Docket No. 50-219

The Commission has issued the enclosed Amendment No. 50 to Provisional Operating License No. DPR-16 for the Oyster Creek Nuclear Generating Station. This amendment consists of changes to the Technical Specifications in response to your application dated August 7, 1980, as supplemented August 14, 25 and 27, 1980.

OYSTER CREEK NUCLEAR GENERATING STATION, UNIT NO. 1

Amendment No. 50  
License No. DPR-16

The offsite organization for technical support shall be as shown on Figure 6.2.1.

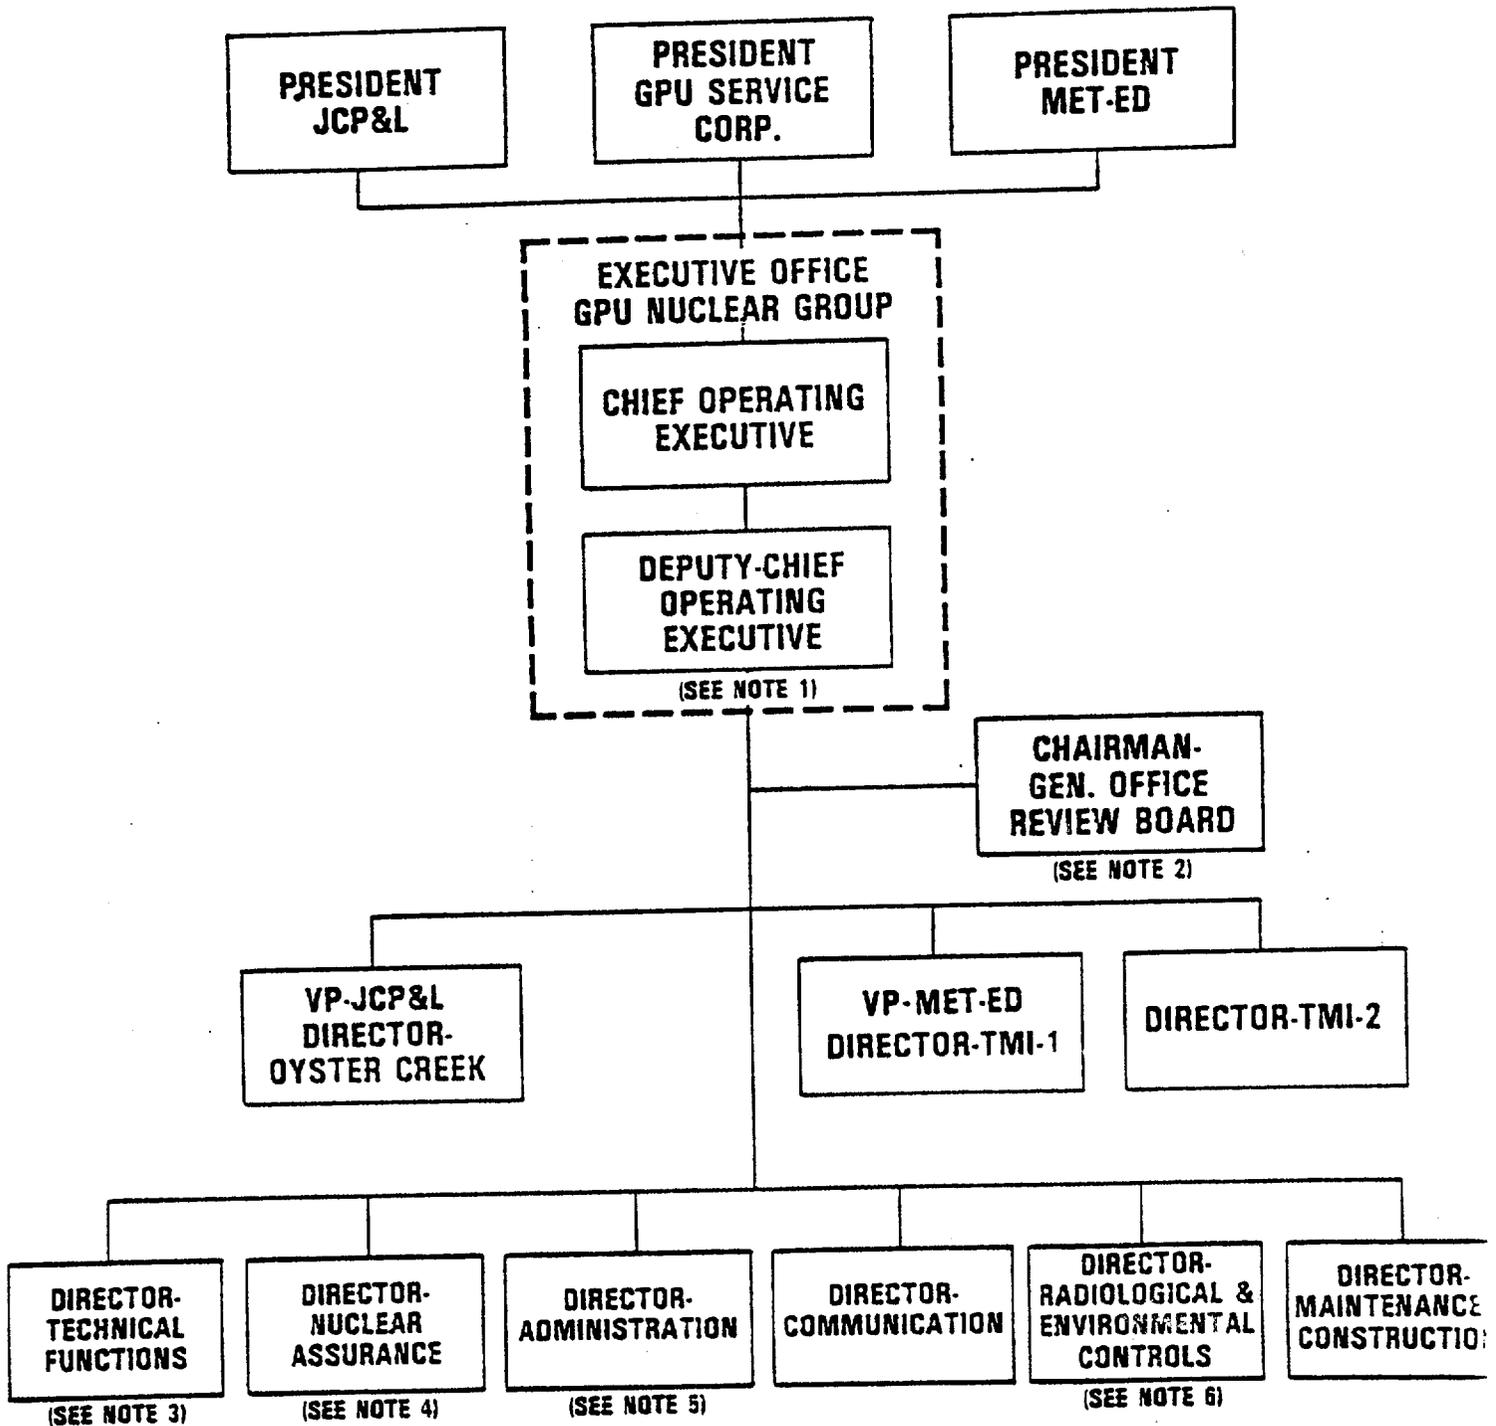
The GPUNG that is being proposed will be organized as shown in revised Figure 6.2.1. The Technical Functions Group, Nuclear Assurance Group, Administration Group, Communications Group, and the Radiological and Environmental Controls Group will provide additional support for the operation of the Oyster Creek Nuclear Generating Station.

The Technical Functions Group consists of the Licensing Systems Engineering Department, the Engineering and Design Department, and the Project Engineering Department. These departments provide engineering and licensing support. The current responsibilities of the JCP&L's Supervisor, Nuclear Safety and Licensing, and the Manager, Generation Engineering, will be transferred to this Group.

The Nuclear Assurance Group is comprised of the Quality Assurance Department, Nuclear Safety Assessment Department, and the Training and Operational Safety Support Department. These departments will provide support in the areas of quality assurance, safety assessment and training. The current responsibilities of JCP&L's Manager, Operational Quality Assurance, will be transferred to this Group.

The Administrative Group will provide support in the areas of security, materials management, personnel and general administrative functions.

The Radiological and Environmental Controls Group will provide personnel and technical support to implement the radiological and offsite environmental control functions for the Oyster Creek Station. The current responsibilities of the Oyster Creek Supervisor, Health Physics, will be transferred to this Group, as well as the environmental monitoring responsibilities of the current Manager, Environmental Affairs. This arrangement for management of radiological control functions assures further independence from station operation and maintenance functions.

FIGURE 6.2.2  
 OYSTER CREEK STATION  
 CONDUCT OF OPERATIONS CHART

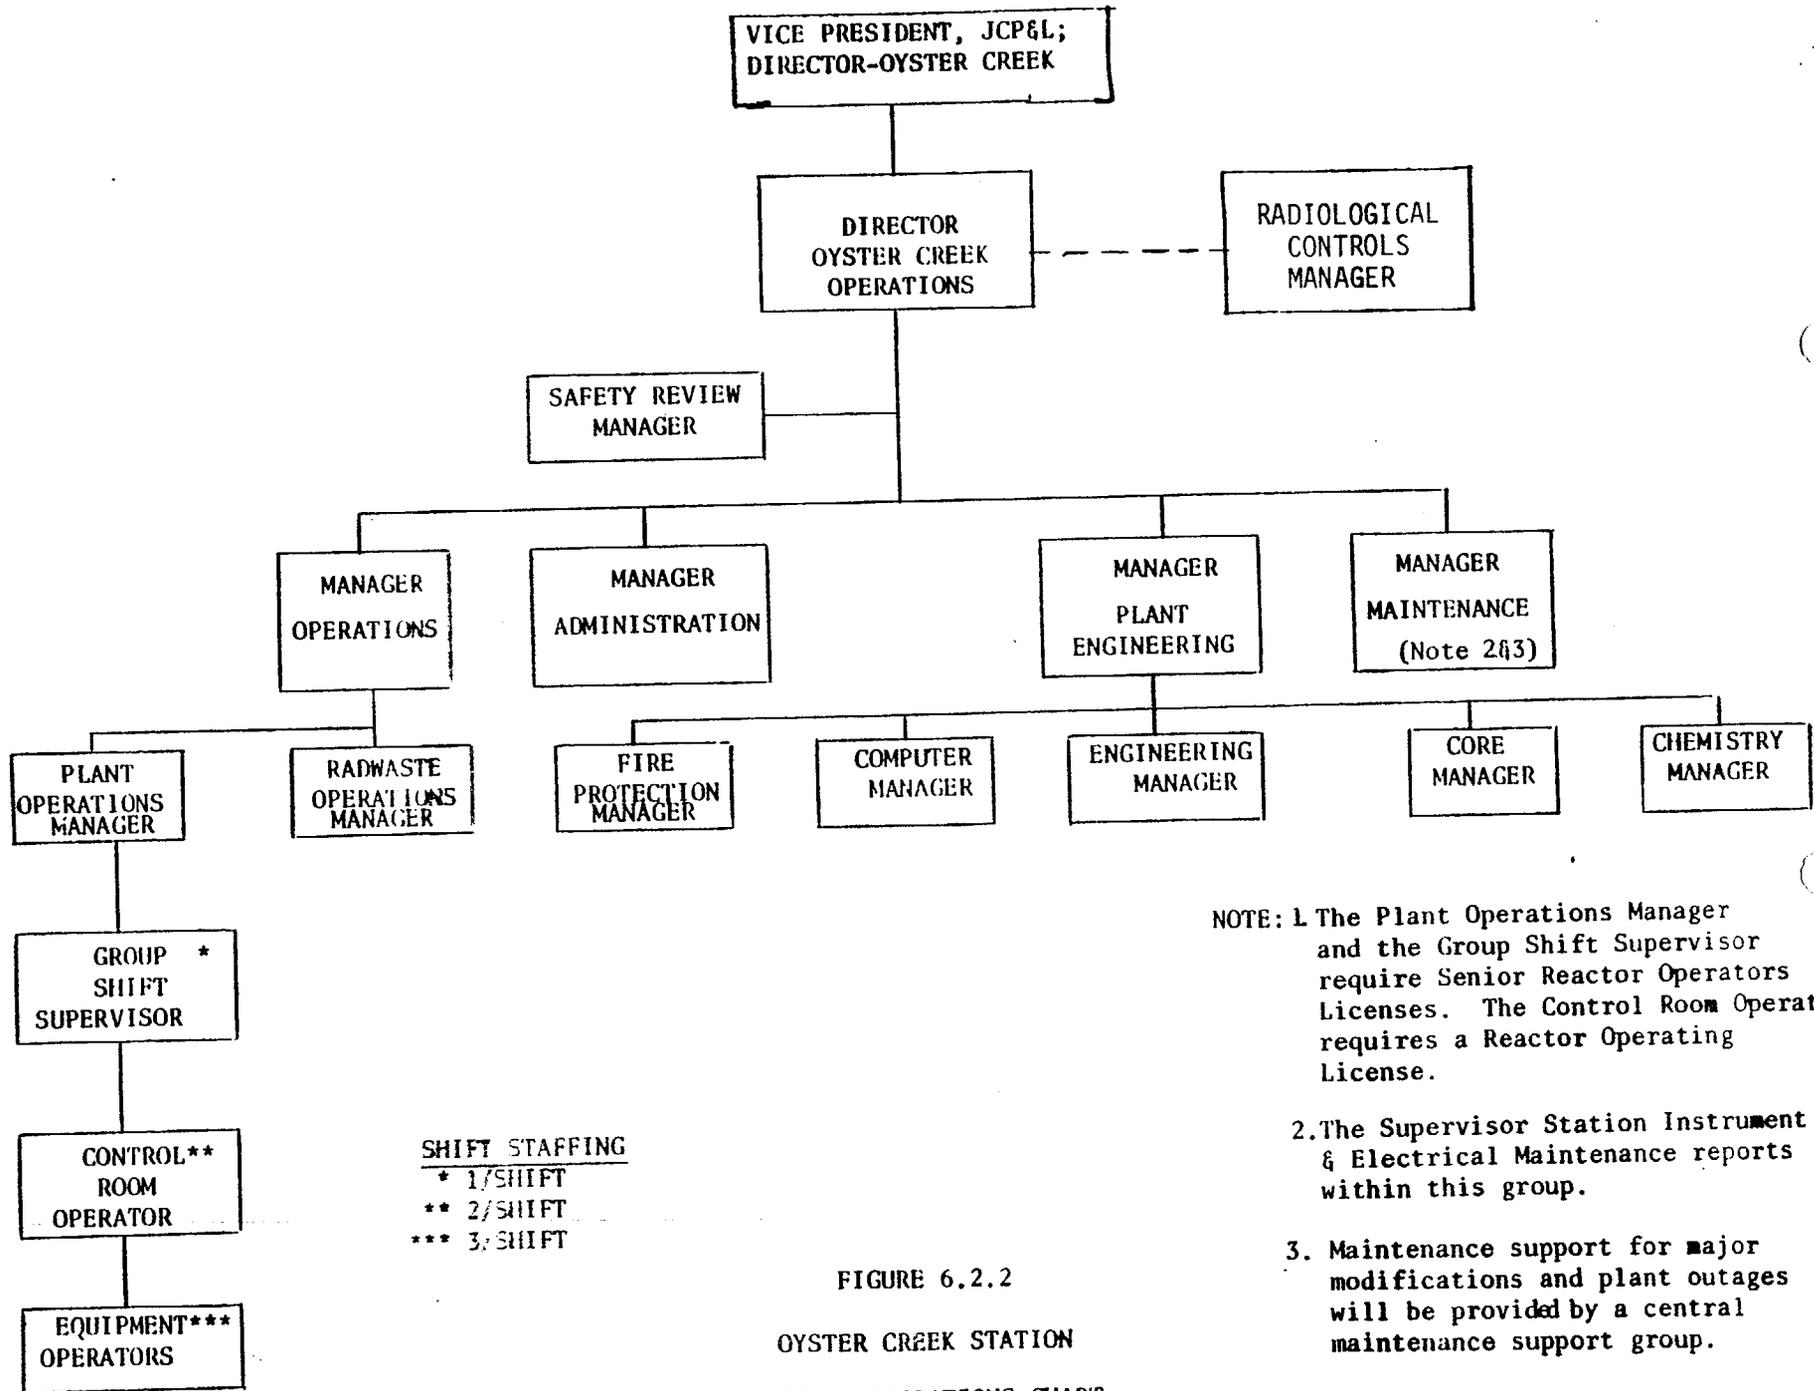
The proposed reorganization of the Oyster Creek plant staff is shown in the revised Figure 6.2.2. The responsibilities of the current Station Manager will be transferred to the Director, Oyster Creek Operations. Reporting to the Director, Oyster Creek Operations, will be the new positions of: Manager, Maintenance, who will be responsible for the Mechanical, and Instrument & Electrical (I&E) Maintenance, currently the responsibility of Supervisor, Station Mechanical Maintenance, and Supervisor, I&E Maintenance; Manager, Plant

Engineering, who will be responsible for those activities currently held by the Plant Support Superintendent; Manager, Administration, who will be responsible for station administrative duties; and Manager, Operations, who will be responsible for functions currently held by the Unit Superintendent, except for maintenance functions which will be transferred to the new Manager, Maintenance. New positions of Fire Protection Manager (reporting to Manager, Plant Engineering), Radwaste Operations Manager (reporting to the Manager, Operations), and Safety Review Manager (reporting to the Director, Oyster Creek Operations) will be established.

The facility organization shall be as shown on Figure 6.2.2 and:

**FIGURE 5-1**  
**ORGANIZATION FOR THE IMPLEMENTATION OF**  
**THE ENVIRONMENTAL TECHNICAL SPECIFICATIONS**

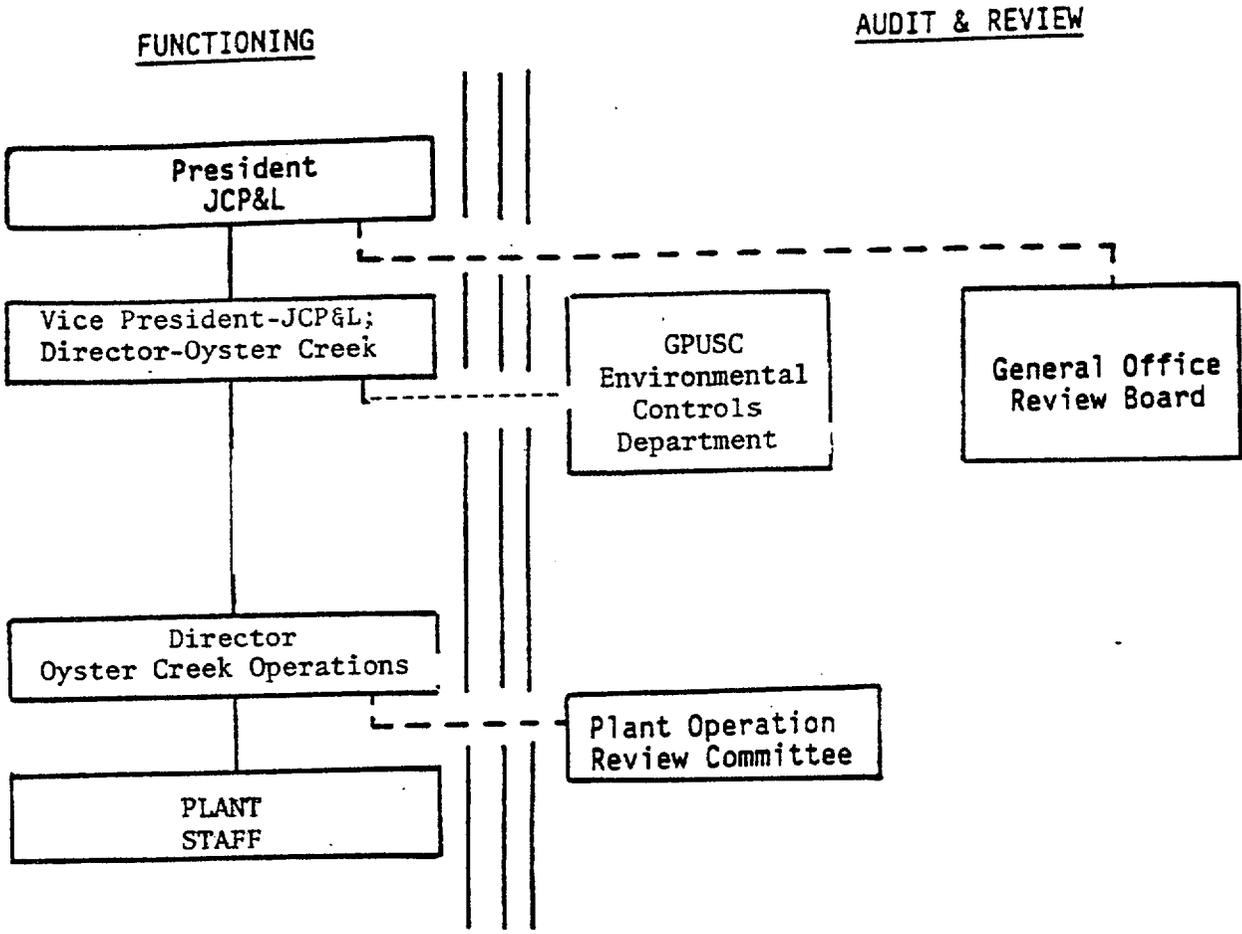
The amendment also changes the Appendix B (Environmental) Technical Specifications to reflect administrative changes consistent with the new organization discussed above. In the new organization, the corporate responsibility for implementation of the Oyster Creek Environmental Technical Specifications and for assuring that plant operations are controlled in such a manner as to provide continuing protection of the environment has been assigned by the President of Jersey Central Power & Light Company to the Vice President, Jersey Central Power & Light Company: Director - Oyster Creek. These responsibilities were previously assigned to the Vice President, Generation. The responsibility for conducting non-radiological surveillance and special surveillance programs has been assigned to the General Public Utilities Service Corporation (GPUSC) Manager, Environmental Controls. In the old organization, these programs were assigned to the JCP&L Manager, Environmental Affairs. Independent audit and review functions for environmental matters are the responsibility of the GPUSC Manager, Environmental Controls. This department reports directly to the GPUSC Vice President, Radiological and Environmental Controls Generation and is independent of line responsibilities for the operation of the plant. This review and audit function was previously provided by the JCP&L Manager, Environmental Affairs.

The organization of the personnel responsible for implementation audit, and review of the OCETS is shown in Figure 5-1.
